RABBIT CREEK COVE SUBDIVISION

APPLICATION NUMBER 19 DATE August 7, 2003

REQUEST Subdivision

DETAIL SITE PLAN

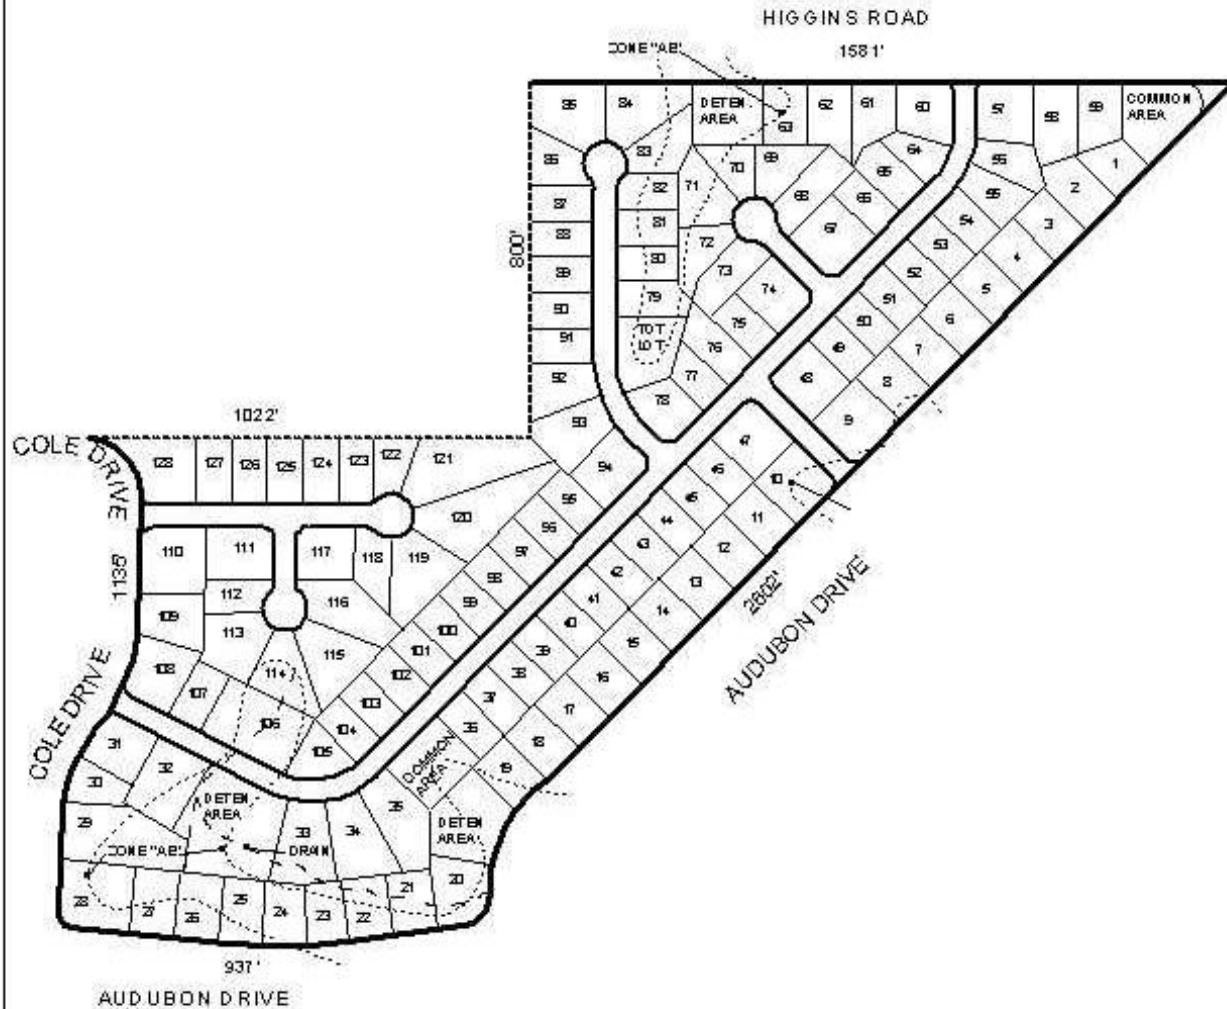
As illustrated on the Vicinity Map, the site adjoins an existing street stub—Clemson Drive. Section V.B.1. states “Existing streets that abut the subdivision shall be continued,” thus a connection with Clemson Drive should be provided. Additionally, the proposed cul de sac to the South of Clemson Drive exceeds the recommended maximum length of a closed-end street (Section V.B.6.); however, if the streets were connected, a waiver of Section V.B.6., would not be required. It should also be noted that the proposed cul de sac to the East of Clemson Drive would require a waiver of V.B.6. (closed end street).

Illustrated on the plat are common areas, detention areas and a tot lot; the use of the areas should be reflected on the final plat with a note stating that the maintenance thereof shall be the responsibility of the property owners.

Numerous lots are located on corners and the corner lots fronting existing streets should be limited to one curb cut to the new subdivision streets; specifically, Lots 57 and 60 should be denied direct access to Higgins Road, Lots 9 and 10 should be denied direct access to Audubon Drive, Lots 20 and 28 should be limited to one curb cut each to Audubon Drive, and Lots 31, 108, 110 and 128 should be denied direct access to Cole Drive.

With modifications and a waiver of Section V.B.1. for the cul de sac East of Clemson Drive, the plat will meet the minimum requirements of the Subdivision Regulations and is recommended for Tentative Approval subject to the following conditions: 1) provision of a connection with Clemson Drive; 2) that the use of all the common areas (detention, tot-lot etc.) be shown on the final plat, with a note stating that the maintenance thereof shall be the responsibility of the property owners; and 3) the placement of note on the final plat stating that Lots 57 and 60 are denied direct access to Higgins Road, Lots 9 and 10 are denied direct access to Audubon Drive, Lots 20 and 28 are limited to one curb cut each to Audubon Drive, and Lots 31, 108, 110 and 128 are denied direct access to Cole Drive.
